COUNCIL REPORT

SUBJECT: REZONING REFERENCE #07-59
1680 AND 1710 GILMORE AVENUE
1771, 1779 & 1791 DOUGLAS ROAD
RESPONSE TO PUBLIC HEARING ISSUES

PURPOSE: To respond to issues raised at the Public Hearing for Rezoning Reference #07-59.

Rezoning Reference #07 - 59
Revised Development Proposal

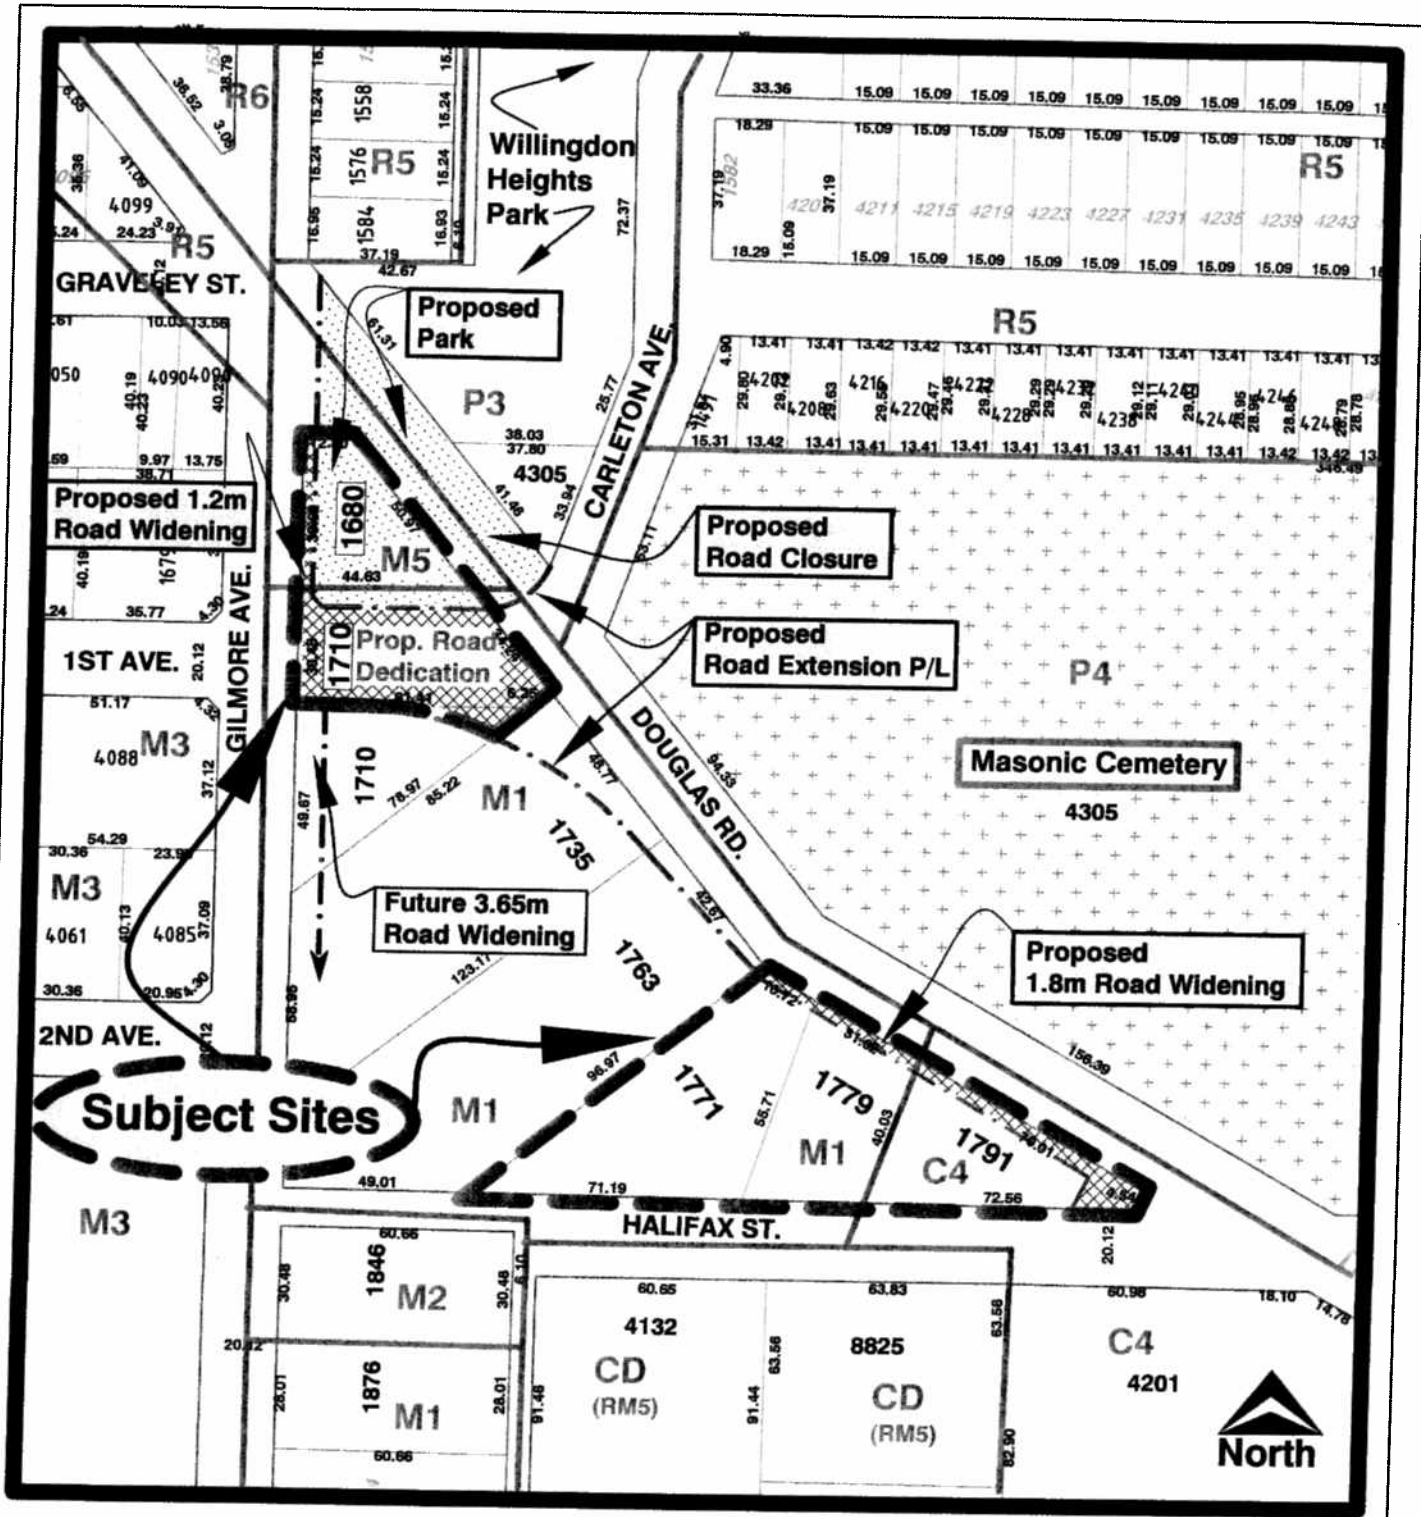
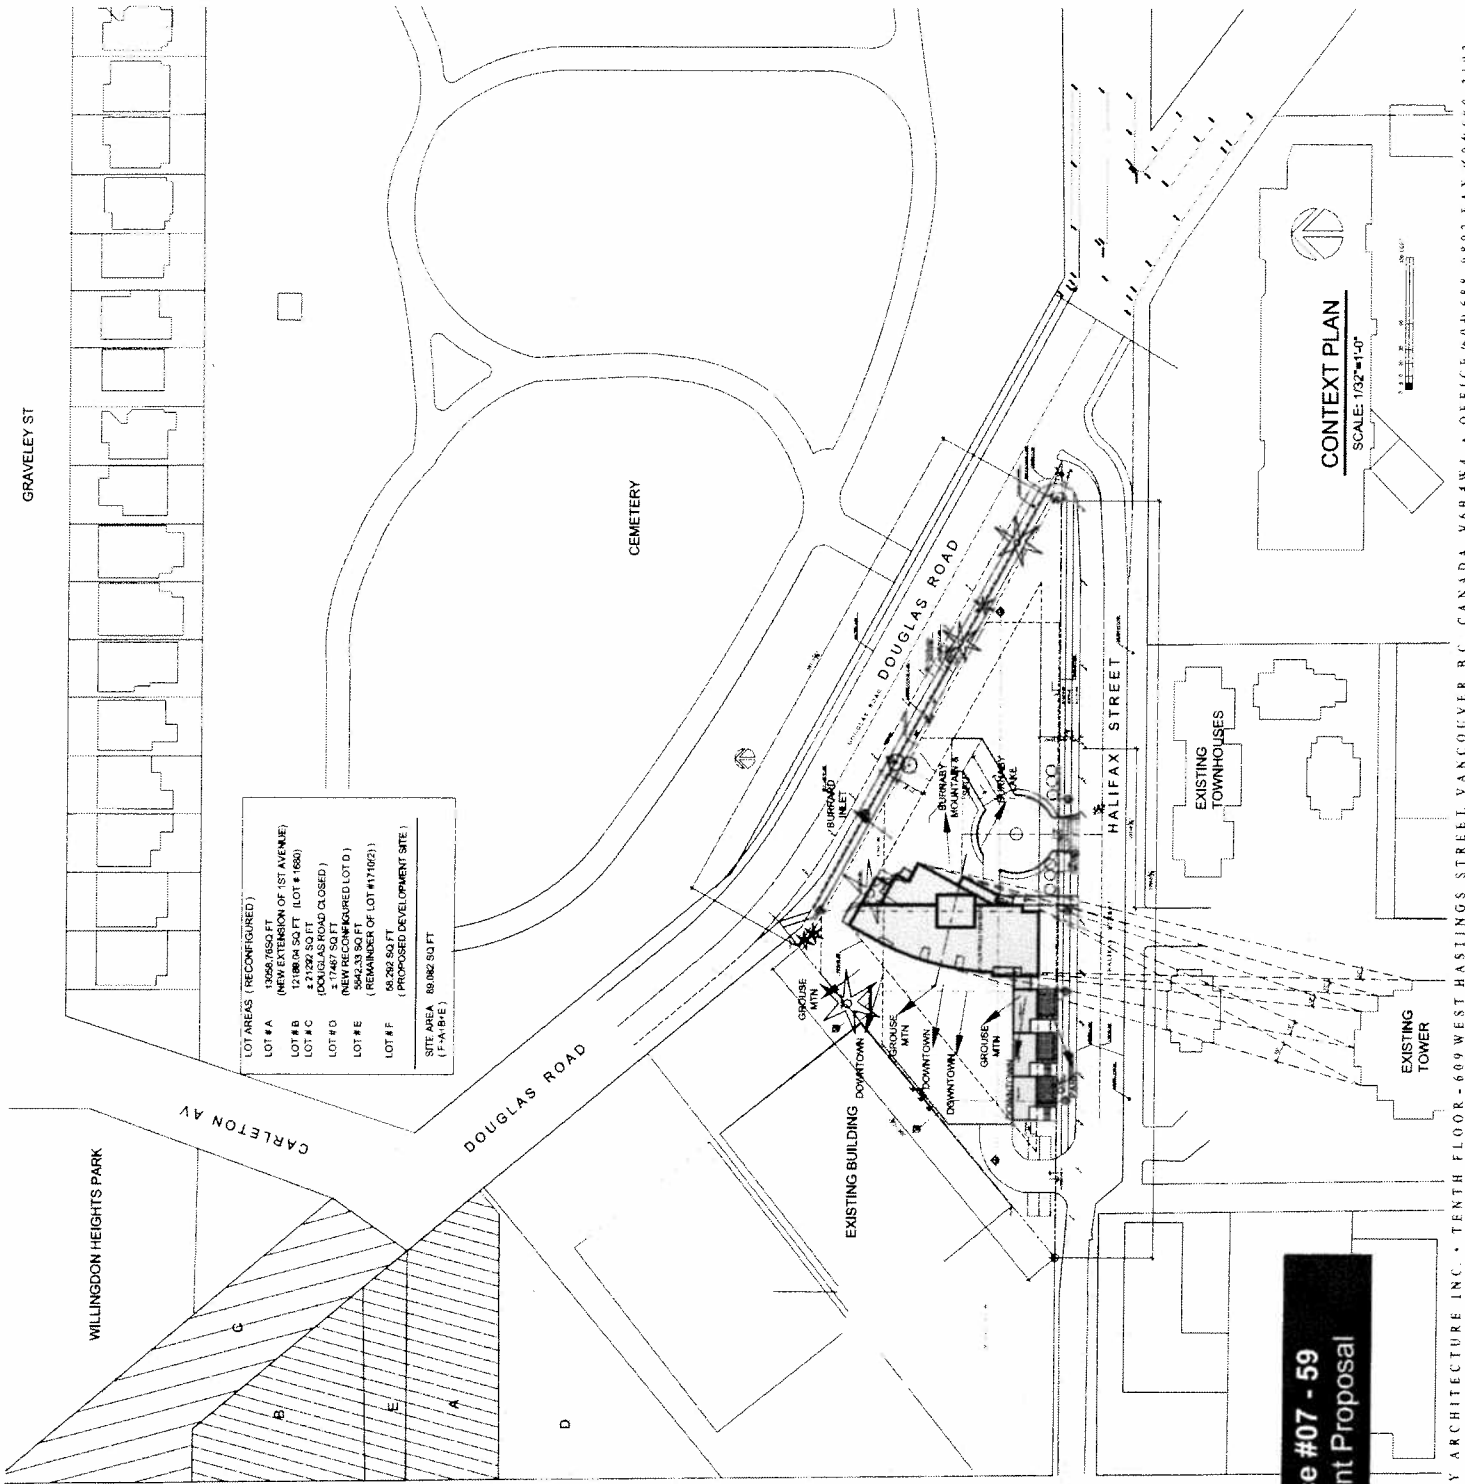
Issue #3 – Views: Several individuals raised concerns over the loss of views, particularly to the north, as a result of the proposed tower's height and location.

All of the concerns raised regarding loss of views came from residents of the 28-storey high-rise apartment tower located at 4132 Halifax Street, across the street to the south of the subject development site. The upper storeys of this high-rise apartment tower have some views to the north, generally of the north shore mountains. As proposed in the Public Hearing drawings for the subject rezoning application, these views would be partially obstructed by a 32-storey residential high-rise building proposed for the subject site.

In response to concerns raised about view obstruction and general visual impact of the subject development proposal, the applicant has been required to modify both the siting and design of the building to lessen its impacts on the existing residential developments to the south. As the subject site is constrained by its size, a steep slope to the south and a triangular geometry, reducing the height of the tower by placing floor area into a low-rise form is infeasible. Instead, the applicant is proposing a departure from the typical point-block (square) tower form in favour of a more rectangular building footprint, with its axis oriented north-south (see **attached** Sketches #3 and #4). By redesigning and orienting the high-rise apartment tower in this way, its profile relative to the residential development to the south is decreased significantly. In particular, this configuration will reduce the width of the tower's southern elevation by nearly 50% (from 19 / 20 degrees to 12/13 degrees of view blockage), thus making it less impactful on the residential development to the south, while maintaining an efficient floorplate in the range of 7,700 sq. ft.

The proposed change to the site's configuration and tower design is considered to have merit and will mitigate concerns raised regarding view preservation and the tower's overall visual impact on the residential development at 4132 Halifax Street.

Sketch # 1

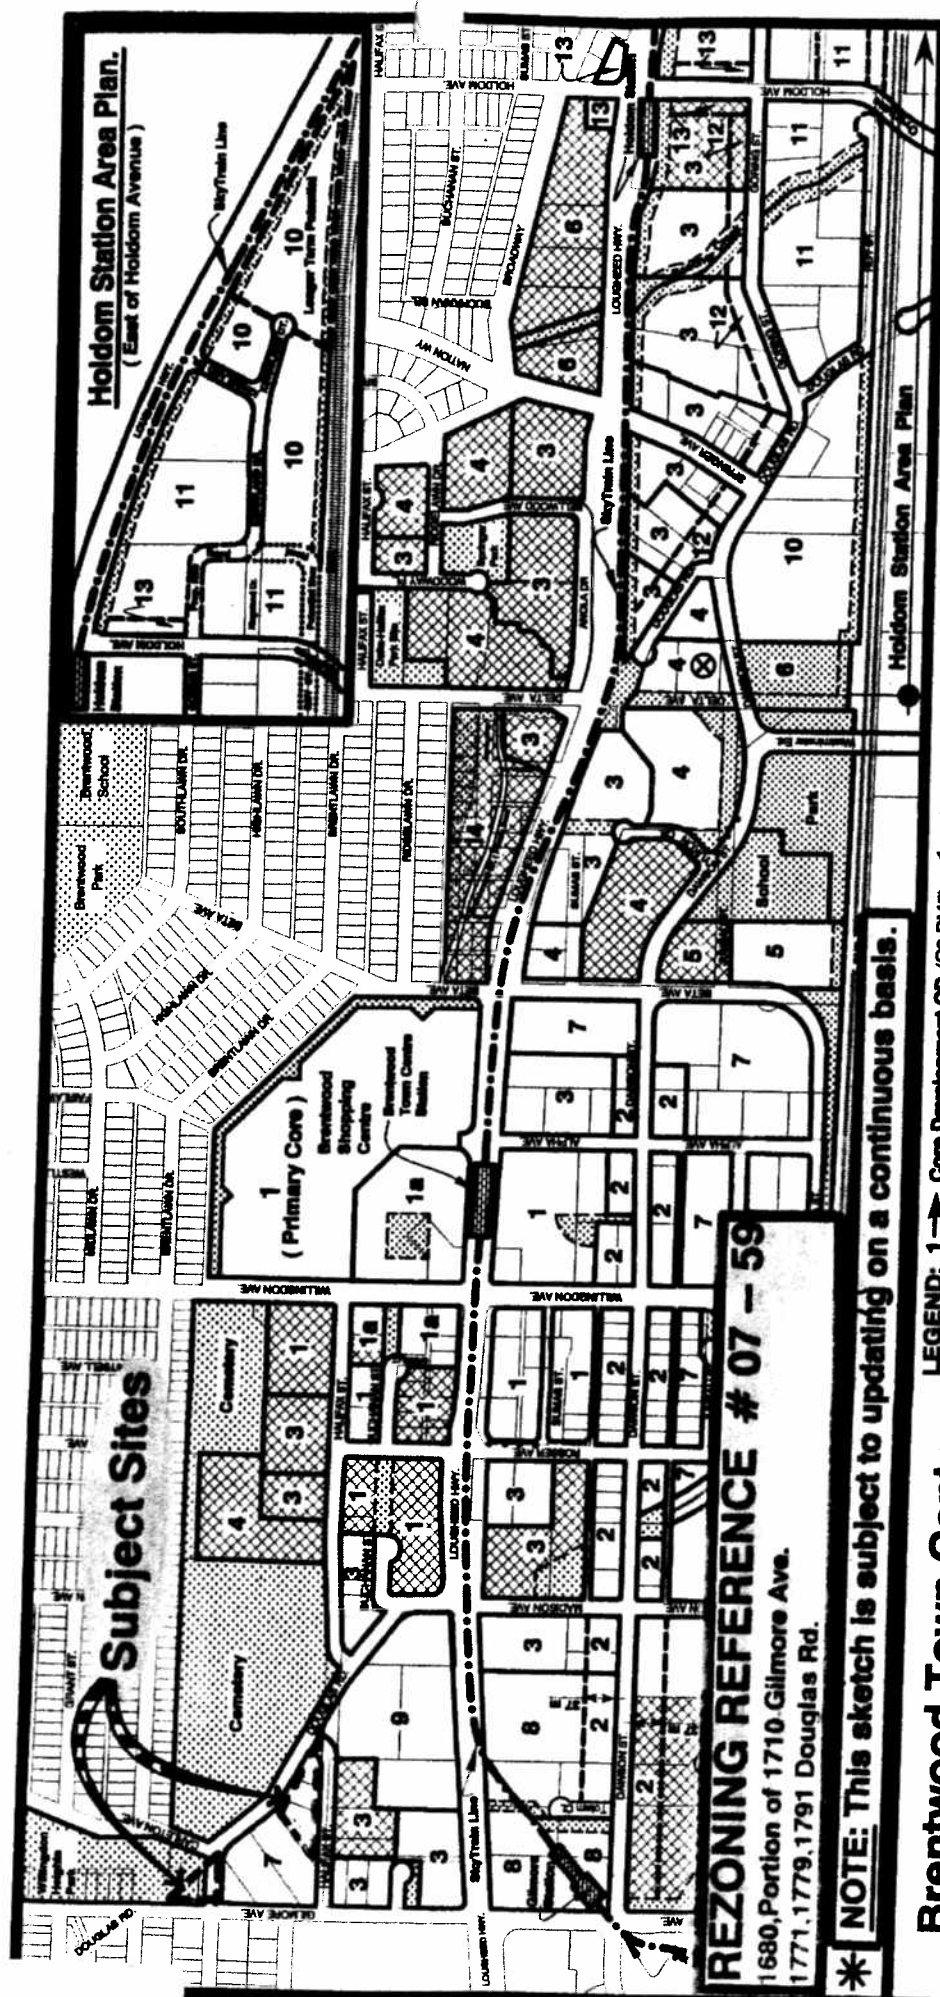
Issue #2 – Community Plan Designation: Concerns were raised over the distribution of copies of the Brentwood Town Centre Development Plan indicating a different land use designation for the subject property on the Plan’s Land Use Concept sketch. Specifically, several individuals indicated they had received a copy of the Plan’s land use sketch from the Planning Department which showed the ‘Succession’ designation as having a Medium Density CD (RM3) guideline rather than simply referencing the area as a ‘Succession’ (Industrial to Multiple Family Residential) Precinct.

Staff acknowledge that a Land Use Concept sketch for the Brentwood Town Centre Development Plan was prepared by the Planning Department in 2002 which showed the Succession designation as having the CD (RM3) or “Medium Density Residential” guideline. This sketch was produced for the purpose of appropriately updating the Succession precinct bounded by Dawson Street, Madison Avenue, Gilmore Avenue and the BNR rail line reflecting the Tandem and OMA developments approved by Council under Rezoning References #02-24, #02-38 and #03-07. The update to this Land Use Concept Sketch, however, inadvertently and incorrectly applied this RM3 “Medium Density Residential” designation to remaining Succession precincts throughout the Town Centre area, including the subject rezoning area. It is noted that the correct land use designation as adopted by Council was indicated in the initial and Public Hearing Reports for the subject rezoning.

That said, however, it is also noted that the adopted Brentwood Town Centre Development Plan provides for the definition of specific development guidelines for each of the Succession precincts at the time of redevelopment, based on circumstances specific to the related precinct. The Plan states “... large sites ripe for redevelopment should be given consideration for advancement on their own merits”. As part of the subject rezoning application, the form, character and density of development for the subject Succession precinct was clarified as part of the noted 2008 May 26 initial report to Council. At that time, it was approved by Council that the subject succession precinct was to be based on the RM5 Multiple Family Residential District in terms of density and high-rise built form. Following Council approval of the designation, staff updated the Plan document to indicate the approved density designation for the subject Succession area and corrected the noted error on the sketch for the balance of the Succession areas. As such, the proposed development remains consistent with the designations and objectives of the adopted Brentwood Town Centre Development Plan, and Council’s established procedures and processes for consideration of each Succession area at the time of development application.
